**Title:** Permit 20-455: St. Stephen's Episcopal Church - 4439 West 50th St., Edina

**Prepared by:** Name: Tom Dietrich  
Phone: 952-473-2855  
tdietrich@minnehahacreek.org

**Recommendation:**

### RETAINING WALL REPLACEMENT PLAN

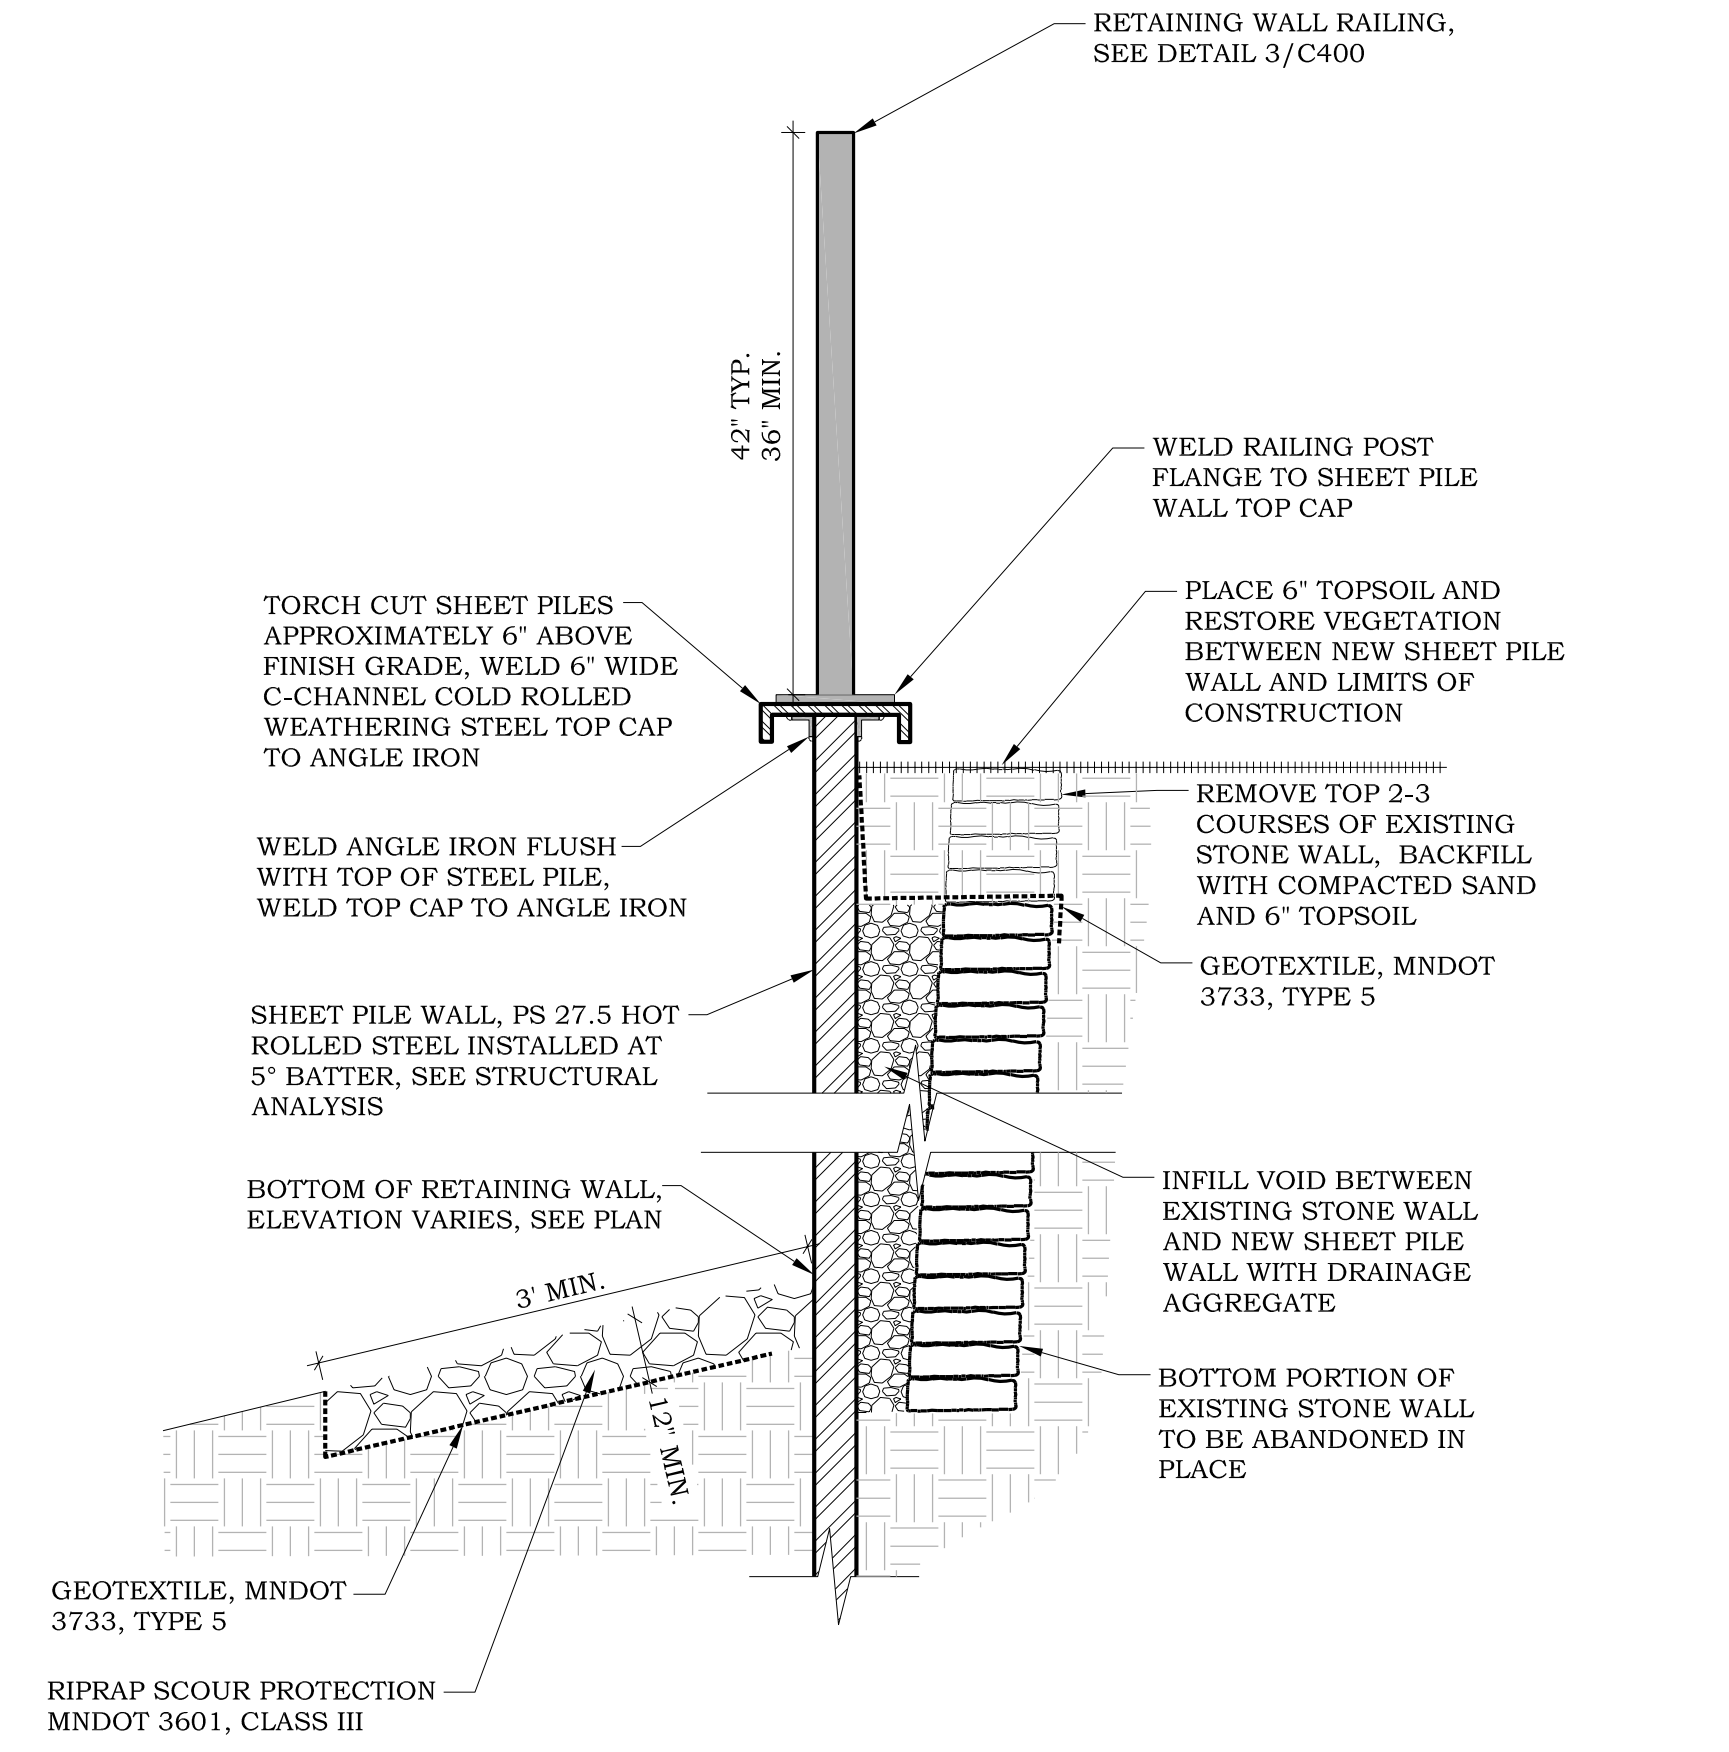
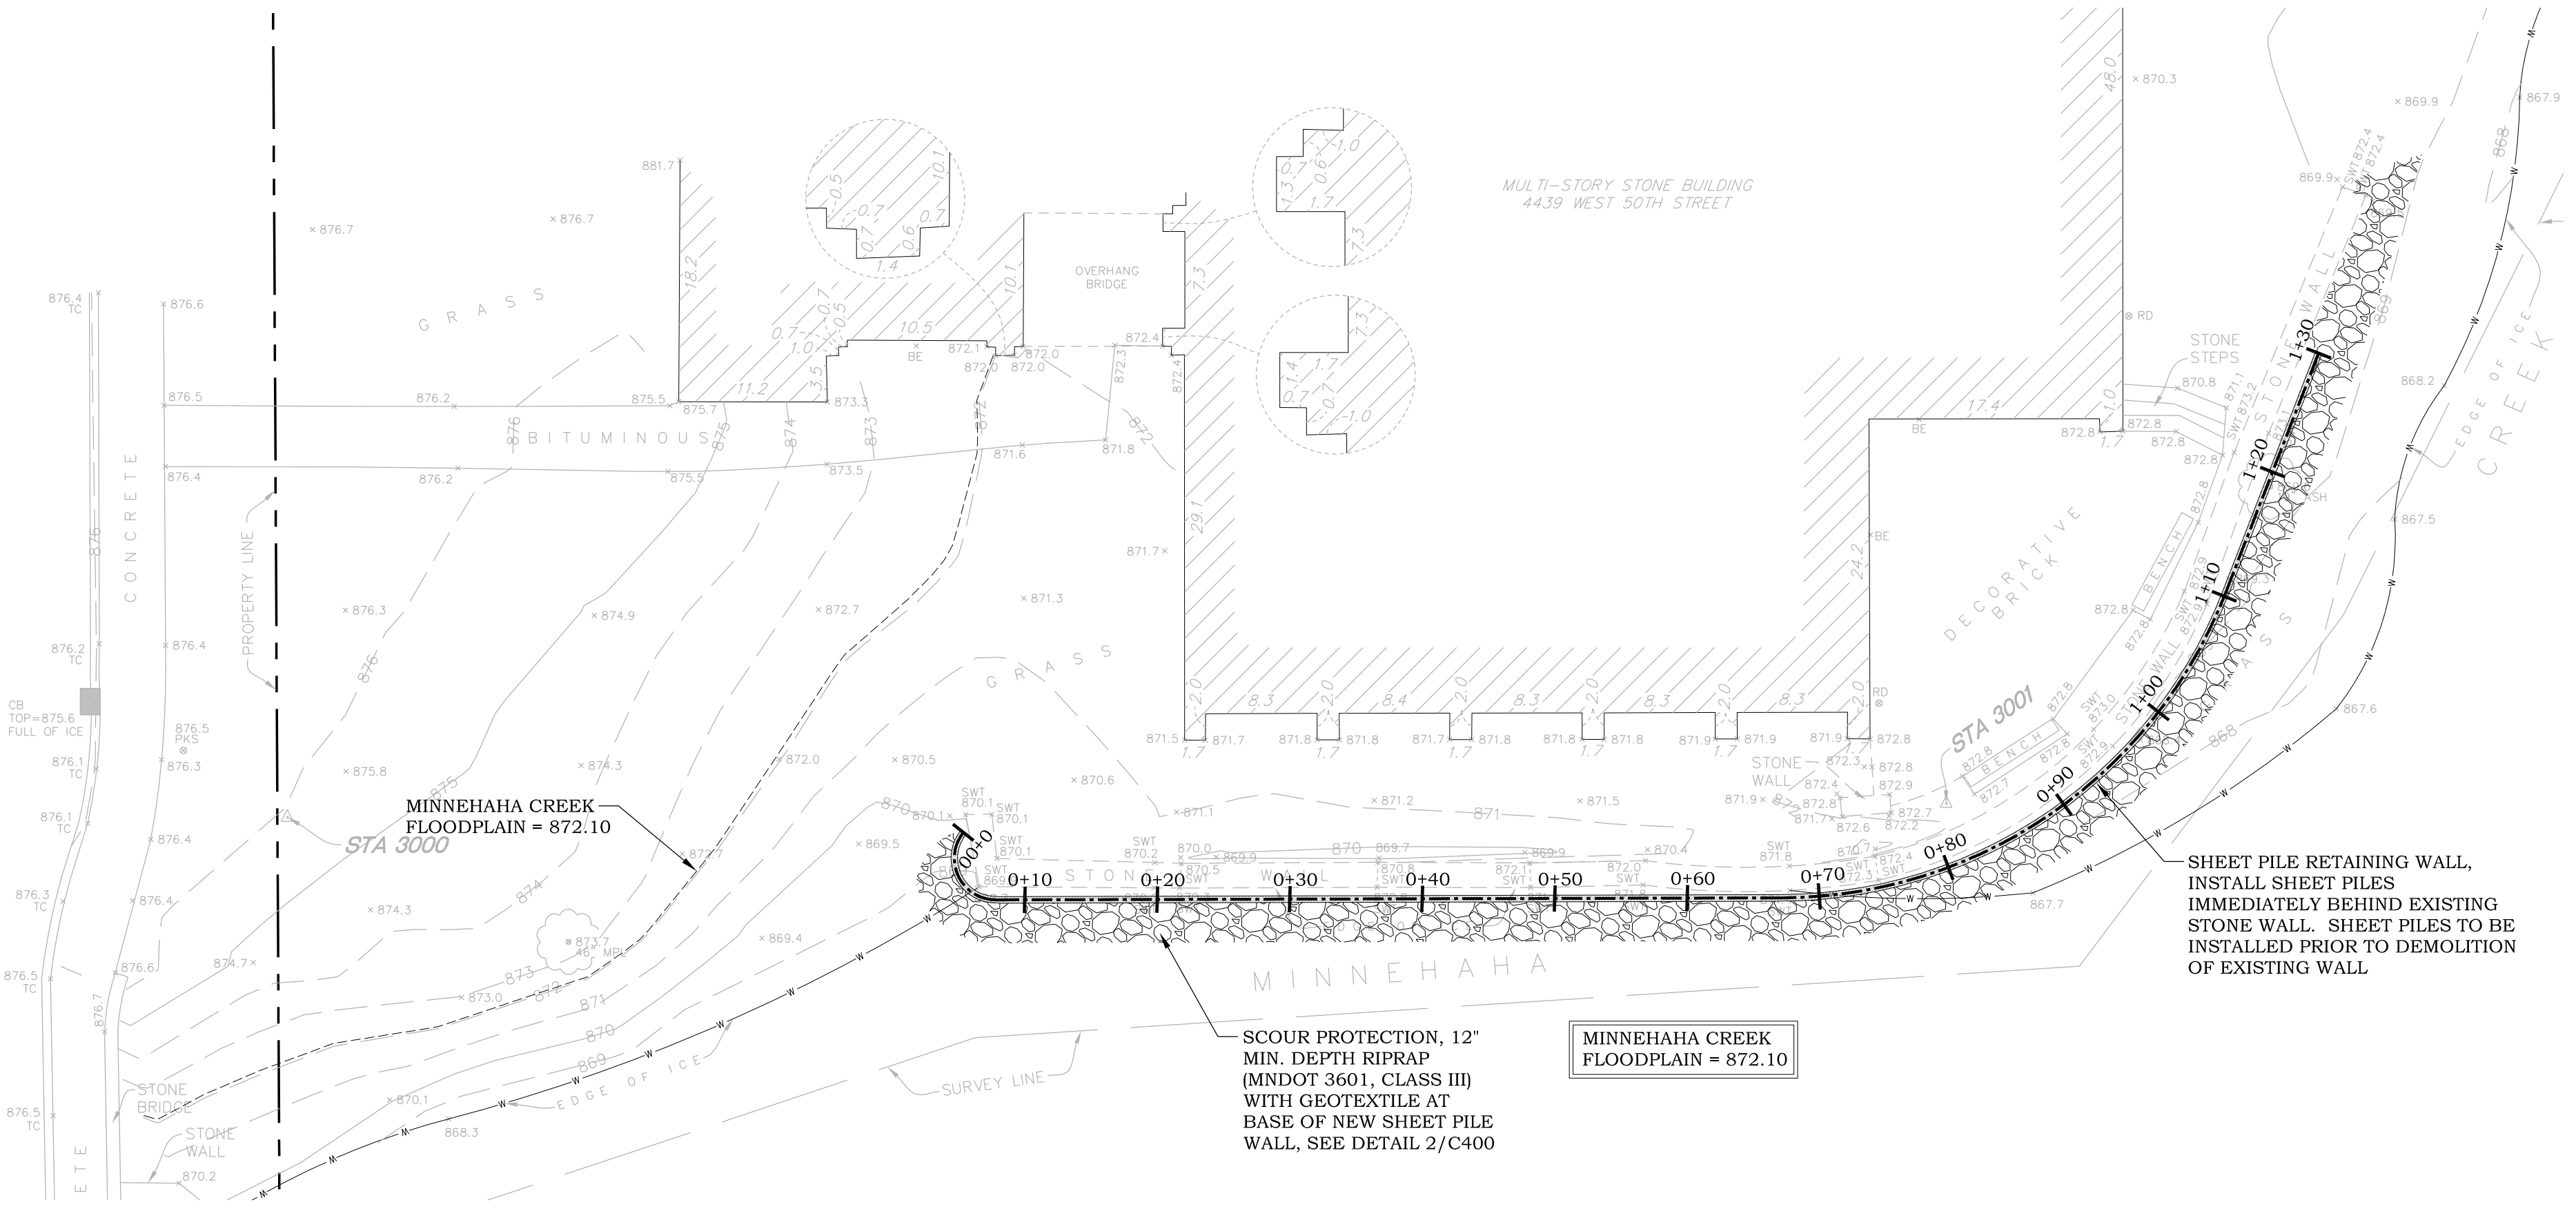
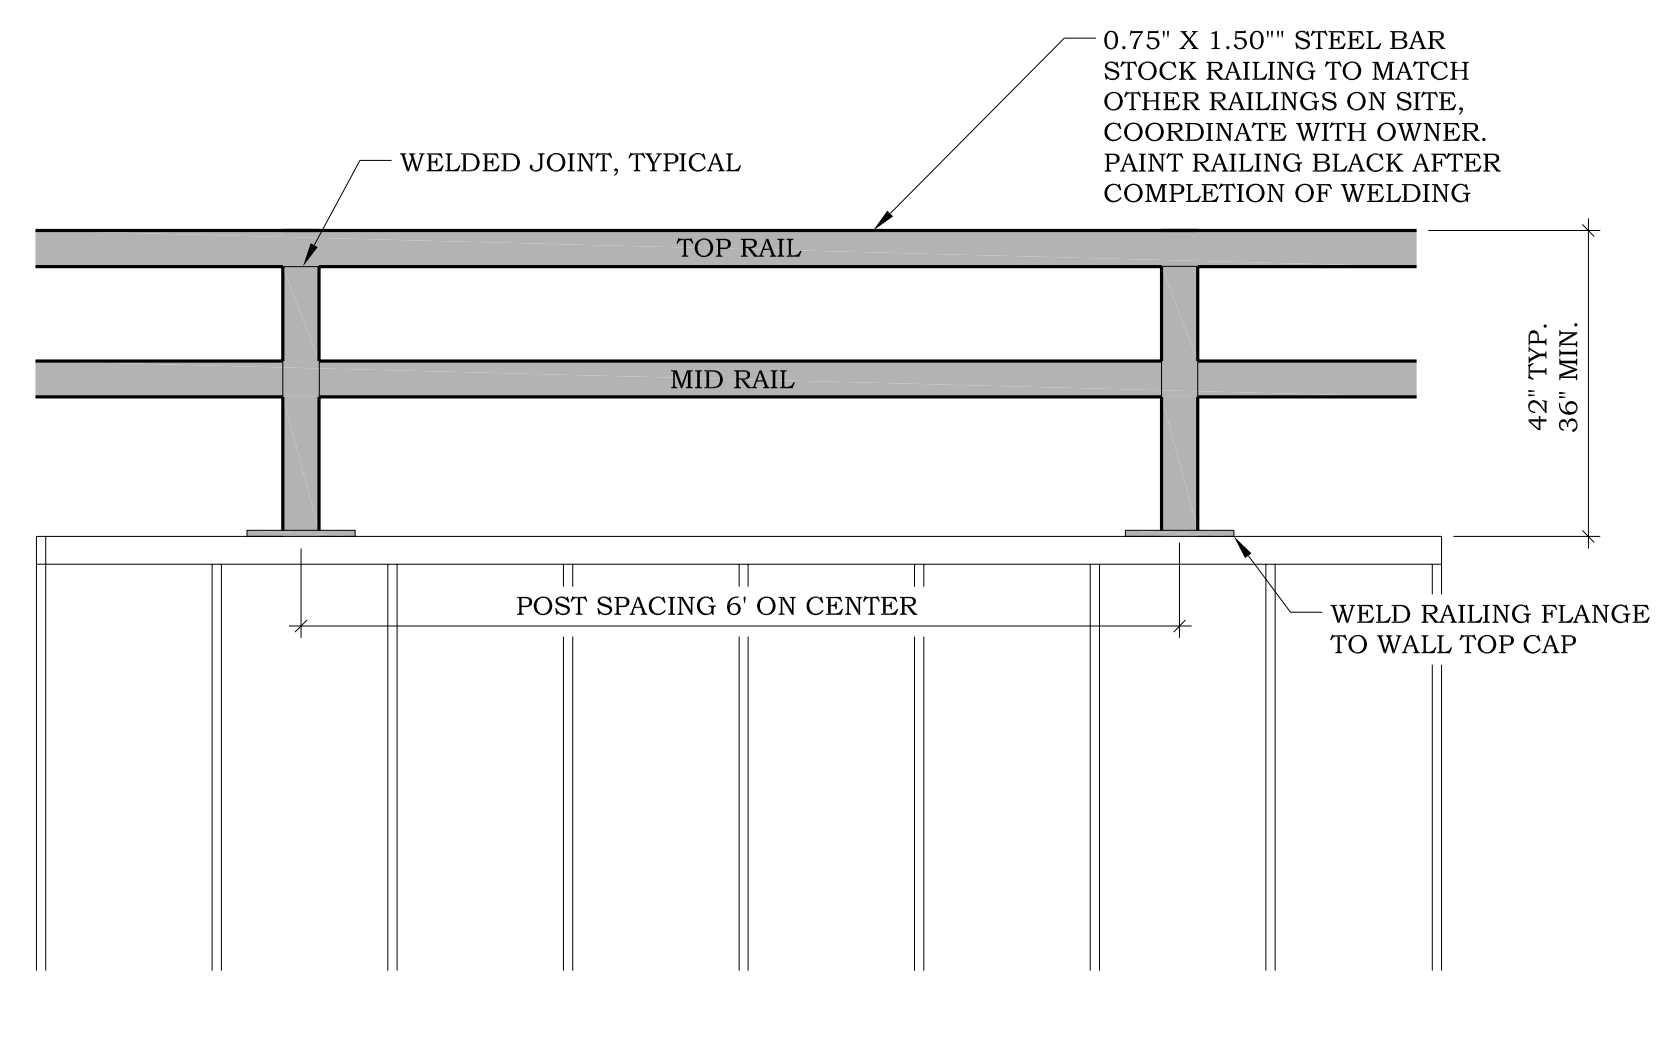
The District's Shoreline and Streambank Stabilization rule regulates alterations and improvements to the banks of a watercourse. The project is proposing to replace approximately 145 feet of stone retaining wall with 0.4 inch-thick sheet pile wall. Additionally, the Applicant is proposing to place hard armoring at the base of the wall to protect the new structure from future scouring and potential damage. Because the replacement of an existing shoreline stabilization practice is proposed, the rule is triggered. For clarity, analysis of the shoreline practices has been separated into two sections – 'hard armoring' and 'retaining wall replacement', detailed below.

As noted above, the Applicant is proposing to replace 145 feet of existing stone retaining wall with 0.4-inch-thick sheet piling. Installation of the sheet piling will occur immediately in front of the existing stone wall. Once the sheet piling is in place, the top 1 – 2' of the existing stone blocks will be removed, and backfilled with sand and top-soil. Section 10 of the District's Shoreline and Stabilization rule outlines four primary provisions when evaluating retaining wall proposals.

The placement of the sheet pile wall in front of the existing stone retaining wall, will on average, reduce the channel width by one foot. The existing channel width is approximately 38 feet wide, and will be reduced to 37 feet in width. The reduction would reduce the effective flow area by about 2.5% in this section of the creek. Although there is a 2.5% reduction in the effective flow area at the project location, the channel maintains a greater than 200% effective flow area comparative to the Wooddale Ave. bridge opening, immediately upstream of this location. The bridge opening at 17.5 feet wide, is the restricting hydraulic constriction for this section of Minnehaha Creek. Therefore, the reduction in channel width at the project location will not represent a hydraulic constraint, and will maintain 100-yr high water levels both upstream and downstream of the project location. Additionally, the encroachment within the floodplain will be offset by grading directly downstream of the wall to provide a 1:1 floodplain mitigation volume, which ensures that no floodplain storage is lost in this section of the creek. Based on this information and the District Engineer's review and analysis, the reduction of channel width in this area will have no effect on upstream or downstream 100-year high-water levels. Therefore, section 10(a) of the rule has been met.

As a component of the project, the Applicant is proposing to utilize hard armoring at the base of the sheet pile retaining wall to protect the structure from scouring and associated damage. An analysis of the proposed hard armoring under the District rule is outlined below.

- 6(a)(3) – stabilization practices must be installed at a 3:1 slope or flatter where practical and feasible.
  - Based on the plans and specifications supplied by the Applicant, the hard armoring will be installed at a 3:1 slope. Therefore, this criteria has been satisfied.

1. Submission of a survey prepared by a registered land surveyor identifying the location and elevations of the finished wall.

Section 10(d) of the District's rule outlines that the applicant must submit a survey prepared by a registered land surveyor location the finished wall and shall file a certificate of survey with the District. This requirement has been included as a stipulation at the top of this report.
